COMMUNITY BOARD No. 2, MANHATTAN

**Re: NYU Core Project; ULURP Applications Nos.: 120122 ZMM, N 120123 ZRM, N 120124 ZSM,
120077 MMM**

The resolution recommends **denial** of each application for the detailed reasons stated in the "Community Board 2 Response" below.

THE CITY OF NEW YORK
OFFICE OF THE PRESIDENT
BOROUGH OF MANHATTAN

Mercer Street Elevation, BP's Recommendation

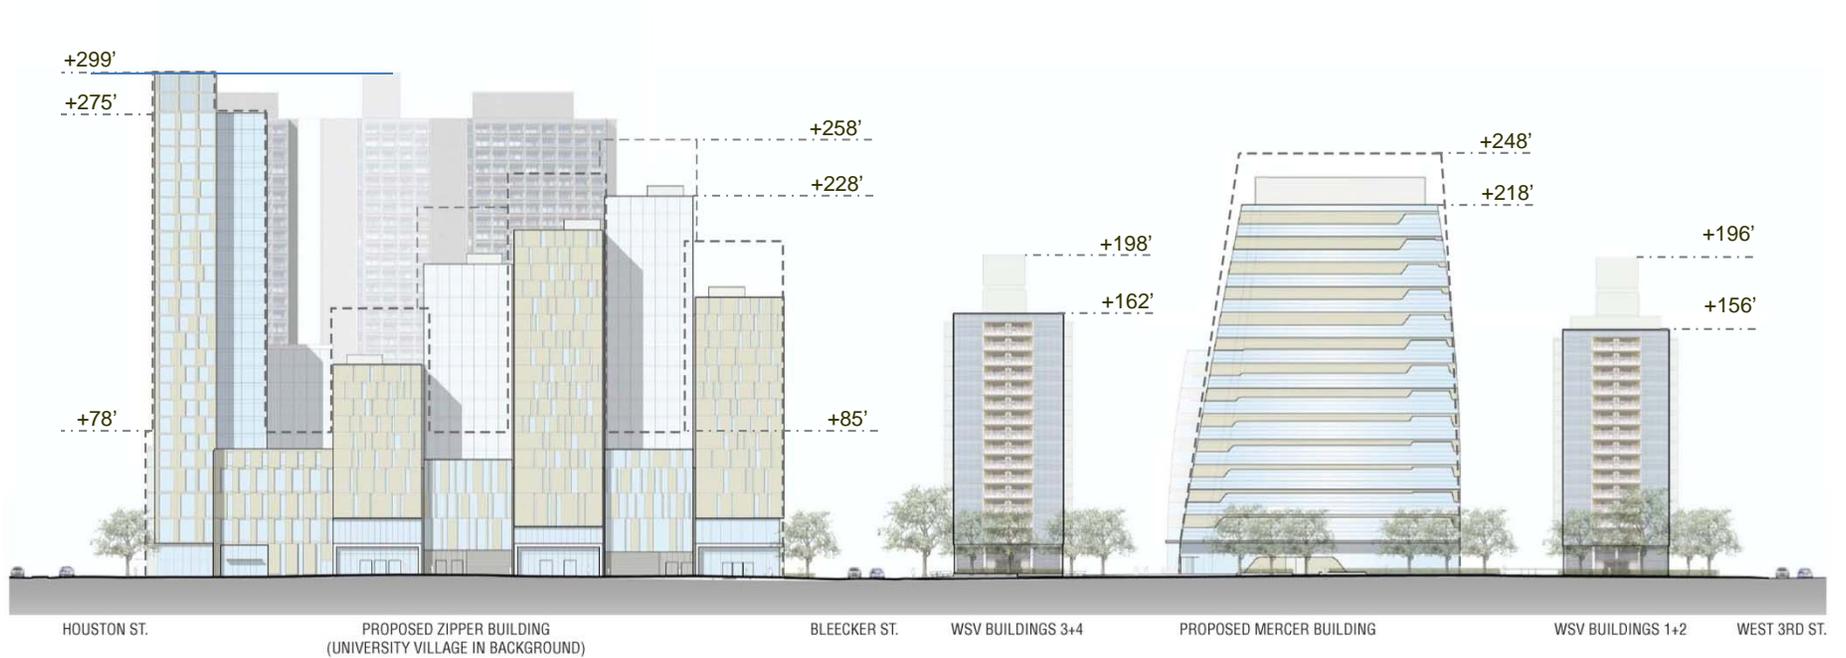
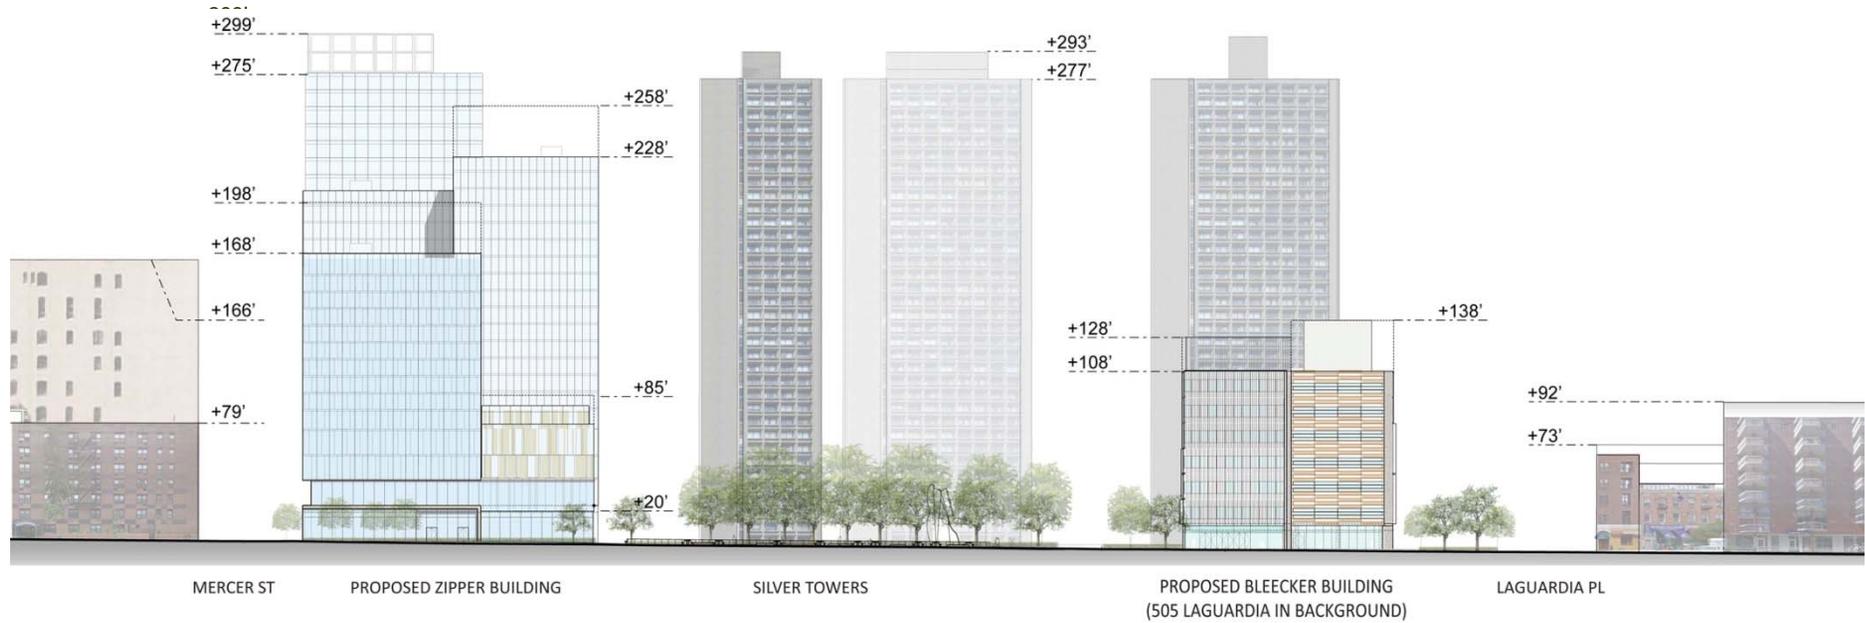
1. **Reduce the total floor area of the proposed construction by approximately 370,000 SF through the following measures:**
 - (a) **Withdraw the application to develop 185,000 square feet below the public parks proposed on WSV;**
 - (b) **Eliminate 85,000 gross square feet from the Mercer and LaGuardia Boomerang buildings and limit the height of the Mercer Boomerang to no more than 162 feet;**
